SUBJECT: GRAND GULF NUCLEAR STATION, UNIT 1 – STAFF ASSESSMENT OF  
RESPONSE TO 10 CFR 50.54(f) INFORMATION REQUEST – FLOOD-  
CAUSING MECHANISM REEVALUATION (TAC NO. MF1102)

STAFF ASSESSMENT BY THE OFFICE OF NUCLEAR REACTOR REGULATION

RELATED TO FLOODING HAZARD REEVALUATION REPORT

GRAND GULF NUCLEAR STATION, UNIT 1

**Figure 3.2-1: Site map with FLO-2D model grid, where brown color grid cells indicate building areas designated as area reduction factors (from the response of RAI 3.2-1 (Mulligan, 2014).**

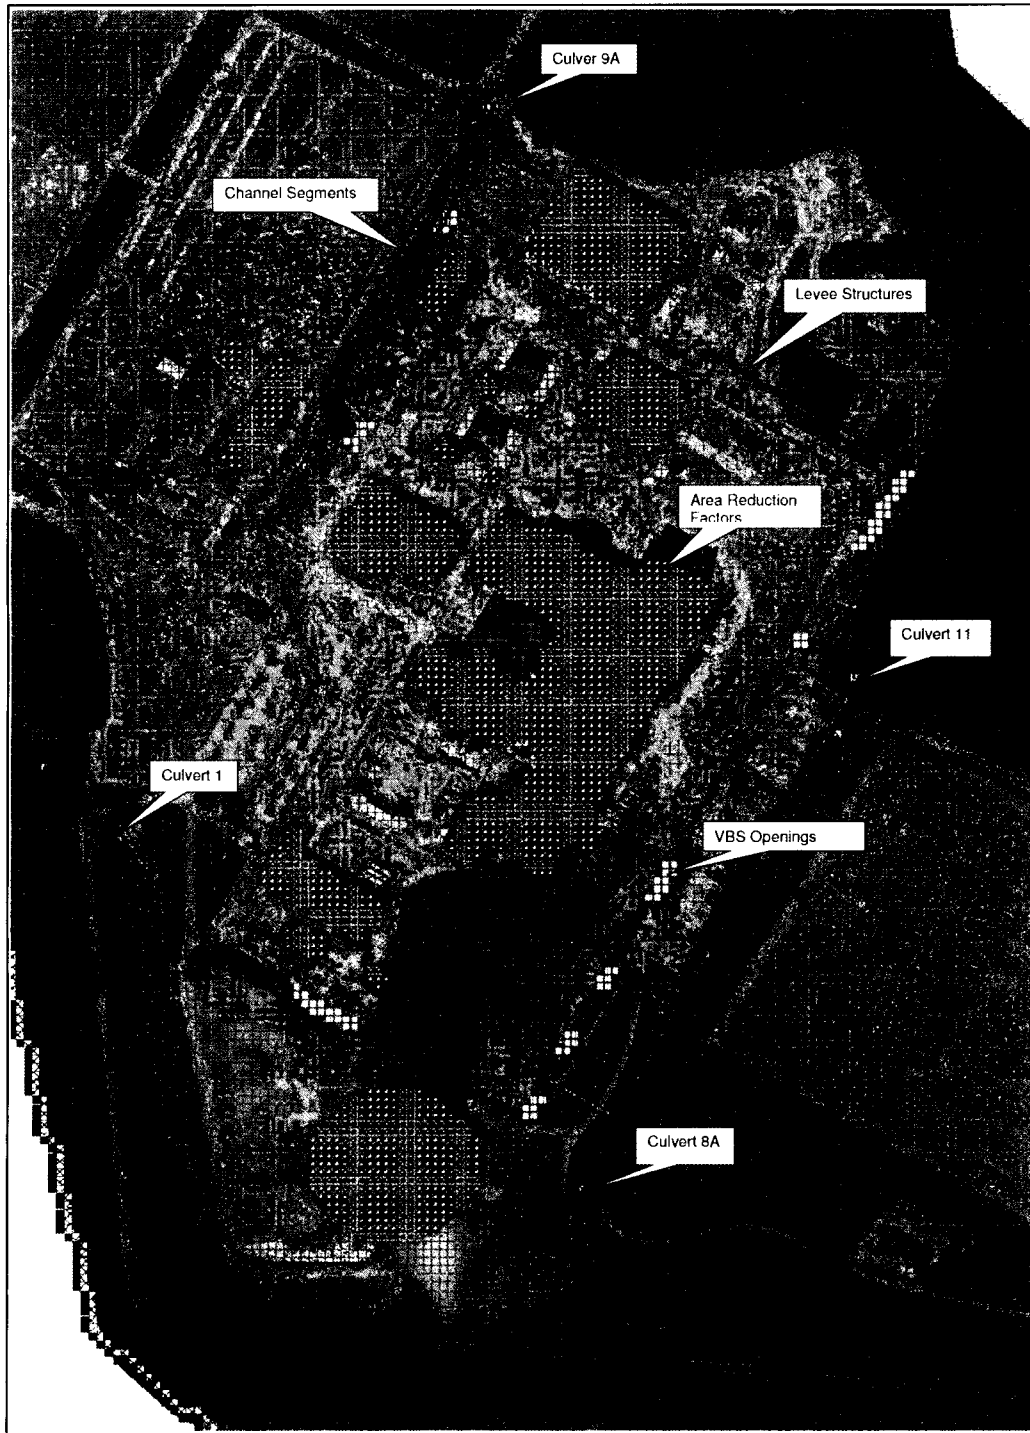
The staff reviewed the FLO-2D model input and output related to the LIP runoff analyses provided by the licensee. The staff identified multiple modeling components of the LIP runoff analyses that appeared to be inconsistent with the descriptions provided by the licensee (Mulligan, 2013; Mulligan, 2014). Because the LIP flooding mechanism is included as part of an Integrated Assessment, the staff determined that these numerical modeling issues should be resolved as part of the Integrated Assessment. These issues are identified as Integrated Assessment Open Items, and are listed in Table 5.0-1. The Integrated Assessment Open Items related to the LIP flood modeling are:

- Integrated Assessment Open Item 1a: In the FHRR, the licensee stated that buildings were represented as obstructions to flow, but provided no description of how precipitation falling on building roofs was represented in the model. The staff found that, in the licensee's FLO-2D model, precipitation falling on roofs did not enter the overland flow domain on the ground. The staff also identified additional modeling issues related to the LIP FLO-2D simulations, such as inaccurate water budgets and unrealistic stage hydrographs (e.g., FHRR Figures 3.1-9, 3.1-10, 3.1-14, and 3.1-16), which show high flood stages even after the ending of the postulated PMP event.

- Integrated Assessment Open Item 1b: The staff could not verify that the 50 percent culvert blockage was appropriately implemented in the FLO-2D model. The licensee is requested to clarify how the reduced culvert discharge had actually been modeled for Culverts 8A, 9A, and 11. The licensee is also requested to clarify that Culvert 1 was configured as described by the licensee in its FHRR and RAI responses.

Figure 3.3-1: Stream A and Stream B basins obtained from Figure 2.4-8 of UFSAR Unit 1 (2012).

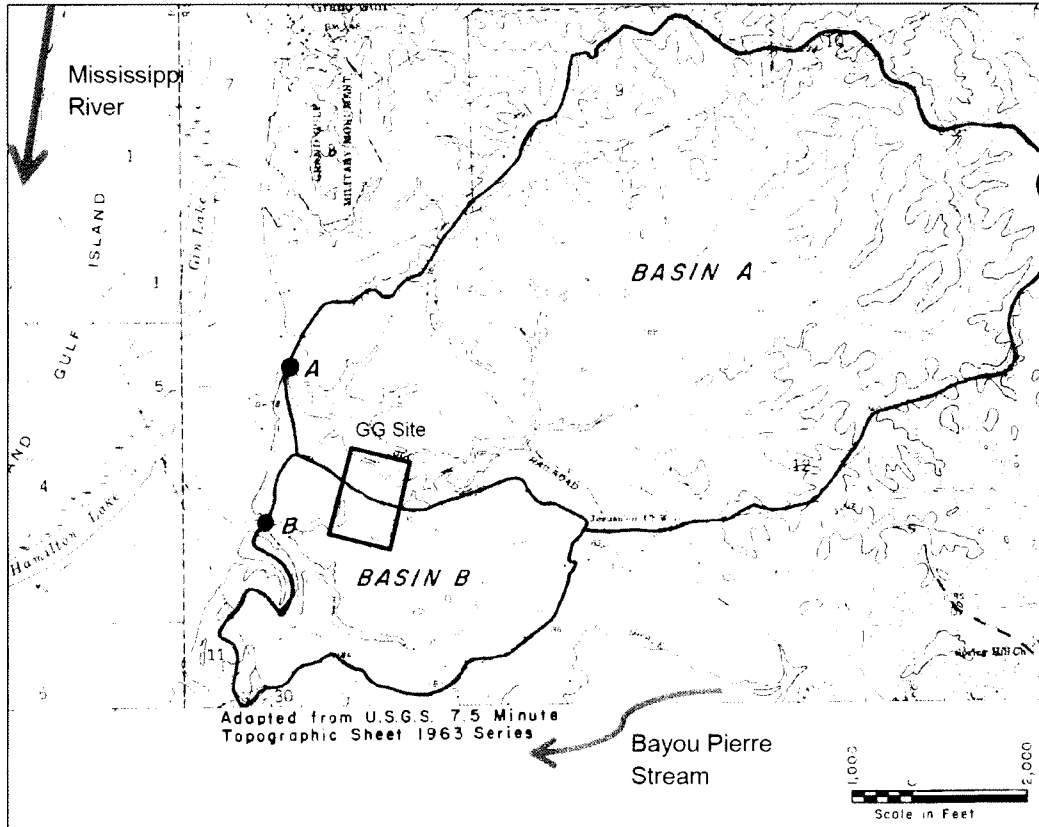
The licensee evaluated the PMF on Stream A and Stream B (see Figure 3.3-1) by: obtaining the basin PMP values using HMRS 51 (NOAA, 1978) and 52 (NOAA, 1982); simulating basin outlet PMF rates using the Soil Conservation Method programmed in HEC-HMS (USACE, 2000) to simulate basin runoff for ungagged streams and assuming no infiltration or evaporation losses conservatively, and; estimating water elevations associated with the simulated PMF rates using FLO-2D that routes both one-dimensional channel flow and two-dimensional overland flow on the vicinity of the plant site.

The staff noted that the northern portion of the onsite drainage channel is connected to Stream A while the southern portion of the onsite drainage is linked to Stream B. The staff also noted that the estimated PMF levels on both streams which are lower than the plant grade are higher than the invert elevations for onsite drainage channel outlets. Because of these site configurations and a PMP event could be applied to all three basins, the staff determined that a combined flood from onsite and basins for Stream A and Stream B could be plausible and more severe than individual floods. In RAI 3.3-4, the staff requested the licensee to provide an analysis of a combined flooding event from onsite and drainage basins for Stream A and Stream B, or to justify why the combined flooding event is not plausible using appropriate topographical and structural data (NRC, 2013c). In response to RAI 3.3-4 (Mulligan, 2014), the licensee described that the PMF determined for Streams A and B includes the site as a contributory area, but with a shorter runoff lag time because (1) the onsite area is mostly paved and (2) the reach of the onsite drainage channel is relatively shorter than those of the streams. The licensee noted that the maximum water surface elevations within the plant site resulting from LIP are not expected to be influenced by floods on Streams A and B. The staff reviewed the licensee's model inputs and outputs related to the Streams A and B analyses and agreed with the licensee's statement that the onsite LIP flood is not influenced by PMFs on Stream A and B mainly due to the difference of peak discharge arrival times at the basin outlets.

**Figure 3.4-1: Bayou Pierre basin with dams (blue dots)**

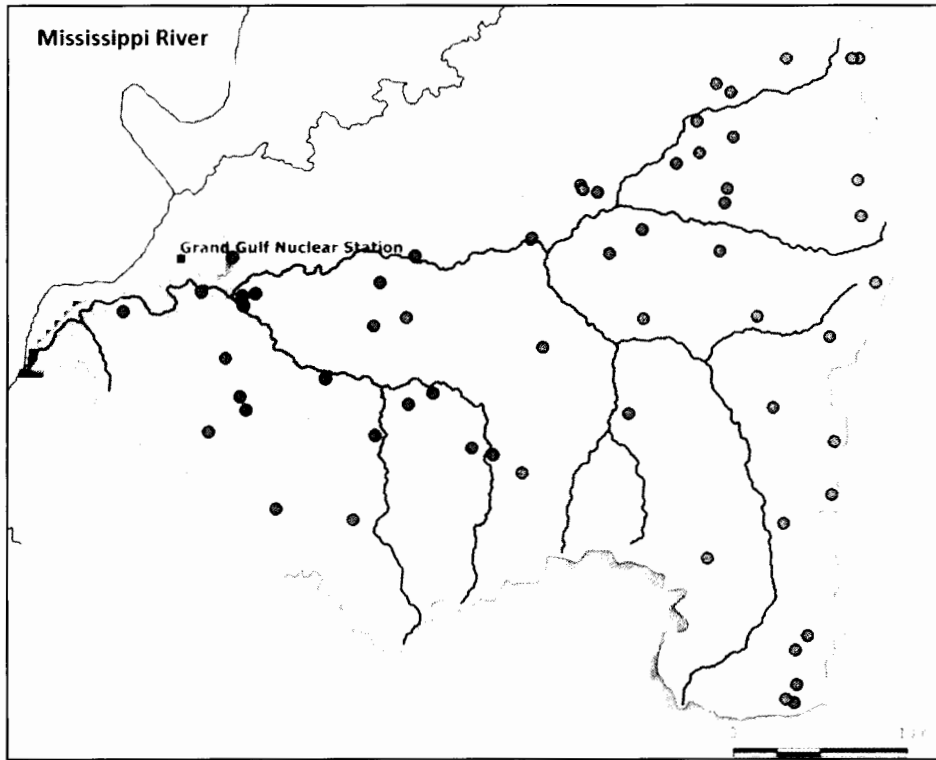
The staff also performed a simple bounding dam failure flood analysis on the Bayou Pierre. The staff identified from the NID Database (USACE, 2013) a total of 59 dams within the Bayou Pierre basin as shown on Figure 3.4-1. The total storage volume of these dams is 34,149 ac-ft (42.1 km<sup>3</sup>), and the maximum storage volume of 15,489 ac-ft (19.1 km<sup>3</sup>) for the Lake Calling Panther Reservoir on the eastern upstream of the basin. The staff assumed that all dams fail and discharge water to the basin outlet simultaneously without loss. The staff estimated the peak dam failure outflow using the bounding breach peak flow equation by Froehlich (1995). The resulting sum of the peak breach outflows was 641,853 ft<sup>3</sup>/s (18,175 m<sup>3</sup>/s). Adding the peak breach flow to the basin PMF rate, the staff obtained a total combined flood rate of approximately 1,376,000 ft<sup>3</sup>/s (38,964 m<sup>3</sup>/s), which was a significant increase compared to the PMF-only rate.

Therefore, in RAI 3.3-3, the staff requested the licensee to provide an analysis of a combined event of PMF, dam failure, and other applicable flood causing mechanisms, or provide a justification if such event is not plausible. In response to this RAI, the licensee stated that Bayou Pierre is not anticipated to overflow the watershed divide between its basin and the site. The staff reviewed the relevant information (see discussion in Section 3.9, below) and agrees with the licensee's conclusion that flooding from Bayou Pierre would not overflow the watershed divide separating it from the GGNS site.
